SSM's external experts' reviews of
SKB's safety assessment SR-PSU
– engineered barriers, engineering
geology and chemical inventory
Initial review phase

SSM's external experts' reviews of
SKB's safety assessment SR-PSU
– engineered barriers, engineering
geology and chemical inventory

Bentonite in geological disposal of low and intermediate level radioactive waste

Figure 1: The existing SFR1 (grey), the extension SFR3 (blue) and access tunnels (SKB TR-14-01).

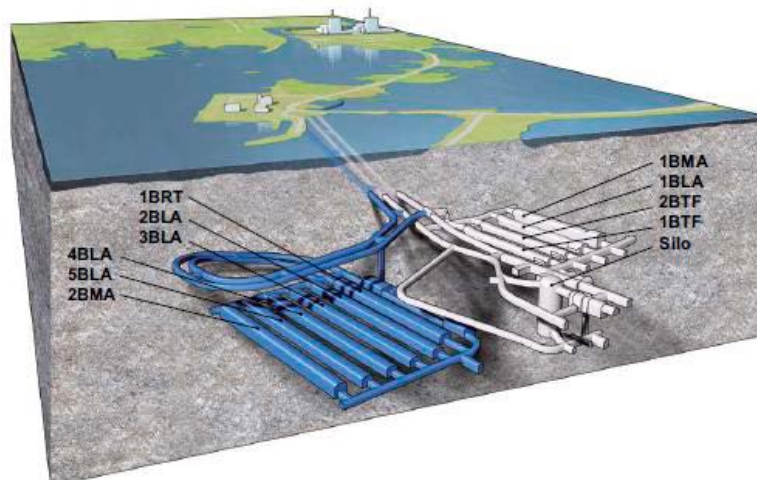
Another important aspect is the direction of waste vaults in SFR 3. According to the layout (Figure 1), vaults are directed toward North-East direction which is almost perpendicular to the direction of major horizontal stress, which is determined to be 142° from North. There must be compelling argument for this decision. If the decision is based on preferred choice of larger horizontal stress to generate arch effect, a more specific explanation need to be presented by SKB and to be evaluated by SSM. Even if existing underground facility in SFR 1 did not show notable instability problem, SFR 3 need more careful approach since it is located around 60 m deeper than SFR 1 which will exert higher stress.

Figure 6: Preliminary layout of the SFR extension relative to the existing SFR 1 and the local model area together with the Forsmark site investigation boreholes and the boreholes from the SFR extension drilling campaign (SKB TR-11-04).

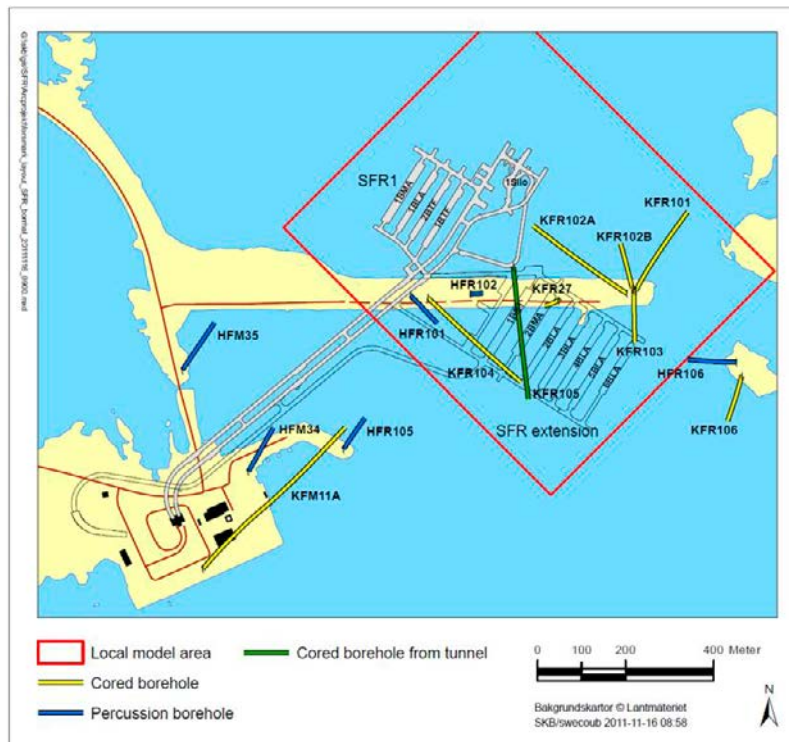
A location of the extension of SFR towards NE and close to the NE border of the regional model could have been an alternative. From existing information about the geophysics, bedrock geology and major deformation zones, the bedrock at that area has favourable magnetic properties (Figure 9-2), is located north of the Northern Boundary Belt (Figure 9-9) and seems to consist of a large homogeneous area of

granite, metamorphic, aplitic rock (Figure 2-2). The slightly longer transport tunnel is of course a negative factor compared with the suggested location by SKB.

Figure 11: Stages of writing and reviewing the Data report. The standard outline for assessing data for a subject area is shown in the grey boxes (Data Report, SKB TR-14-10).

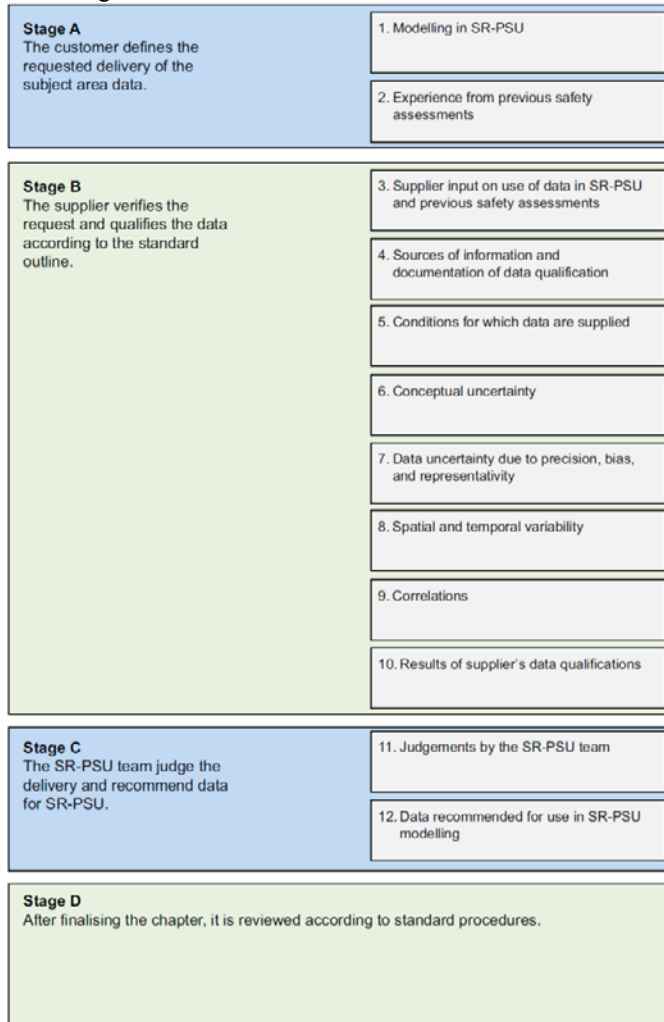
SKB is presenting a scheme of preparing and reviewing the data report for safety assessment (Figure 11). It is not clear from the text and list of references if the suggested procedure is in accordance with international recommendations and standards or it is fully developed by SKB. The procedure follows four stages and all together 12 steps for formulating a subject area. Each of the twelve steps is well written and gives clear instructions to the team developing the data report. Sections 2.1.6 - 2.1.9 about conceptual uncertainty, representativity, variability and correlation are of good quality and the list of questions provided for the individual sections are relevant and well formulated. To make the final assessment for

Figure 15: Measured settlements of silo in SFR 1 and prediction by viscoelastic model (Figure 7-5, Initial state report, SKB TR-14-02).

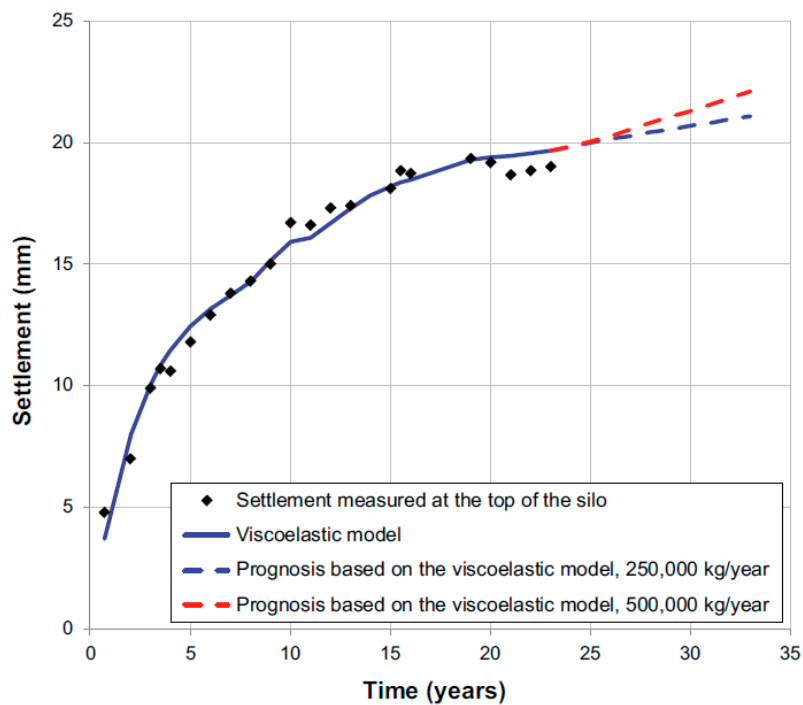
However, SKB gives no explanation about how the modelling is conducted and reference is not given. One can wonder why monitoring data were presented only by 2010. More detailed and elaborate analysis for the silo will be desirable given the size and importance of the structure. If possible, this stability analysis can include the inflow prediction as well in order to prove the level of understanding. Upgraded modelling of the silo is recommended especially because most of modelling was conducted over thirty years ago and recent modelling work is very limited (Carlsson and Hedman, 1986; Carlsson and Christiansson, 1986; Larsson and Christiansson 1986; Stille and Fredriksson 1988, Björk and Malmström, 2004).

Figure 17: Finite element model used in SKB report (SKB R-13-52). Geometry overview (left), full element mesh (centre), and section through the centre of the model (right). The rock mass surrounding the Silo was not modelled in this analysis.

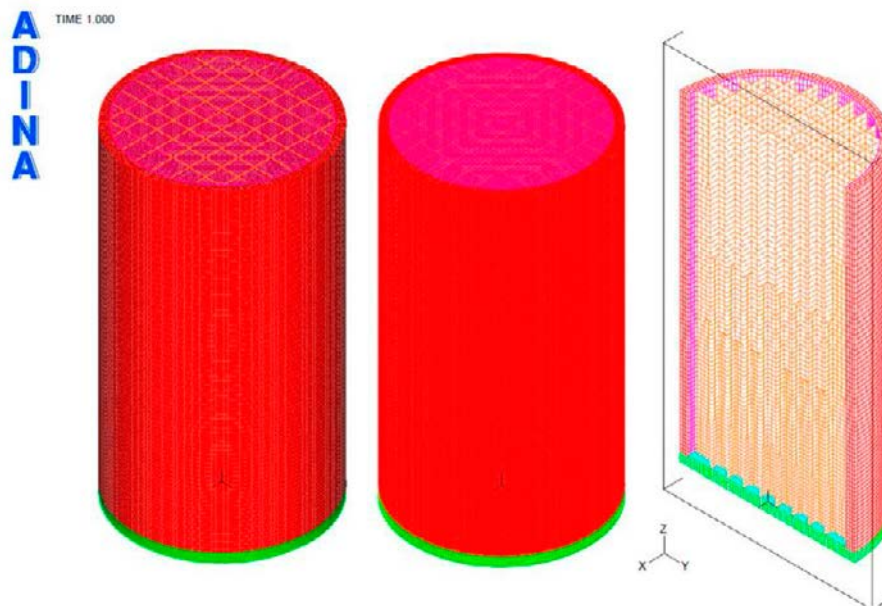
It is noted that the whole analysis was conducted only on the concrete structure without specific consideration of the underground rock structure (Figure 17). Important conclusion from this report is that the SFR Silo structure will maintain its integrity under the loading from an earthquake with an annual exceeding frequency of 10^{-5} . However, with annual probability level of 10^{-6} and 10^{-7} , the structural integrity cannot be guaranteed because extensive cracking in the outer wall, tension in the casting joint between the slabs and outer wall and inner walls experiencing stresses significantly above the tensile limit strength can be expected.

Figure 21: Overview of 2BMA (SKB Document ID 1245480).

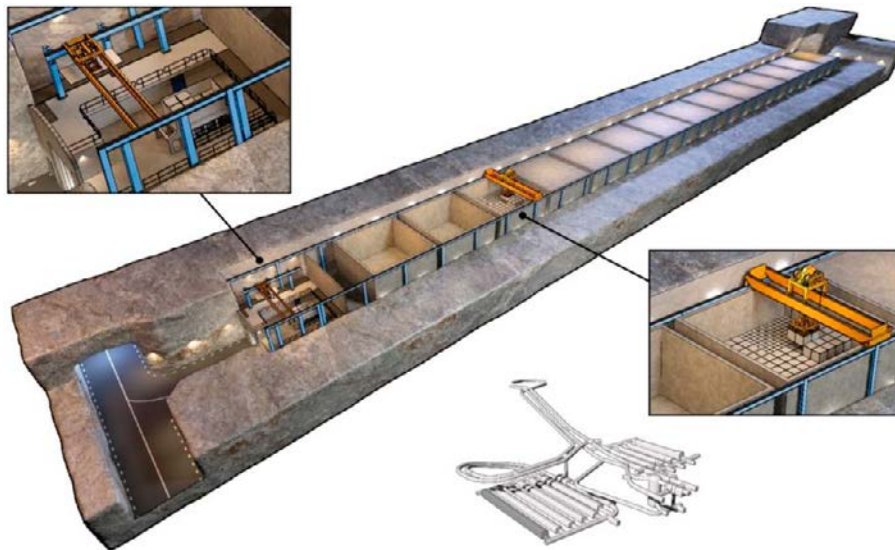
In 2BMA is planned to have 14 free standing caissons (Figure 21). In the safety analysis for 2BMA is stated that the caissons will be of unreinforced concrete and the walls and roof will be lined with shotcrete. The design is different from 1BMA and raises the question why the caissons are made unreinforced and what is the purpose of using shotcrete on their walls and roof? Further, SKB has not presented what type of construction will be made to prevent drops from the roof into the caissons.
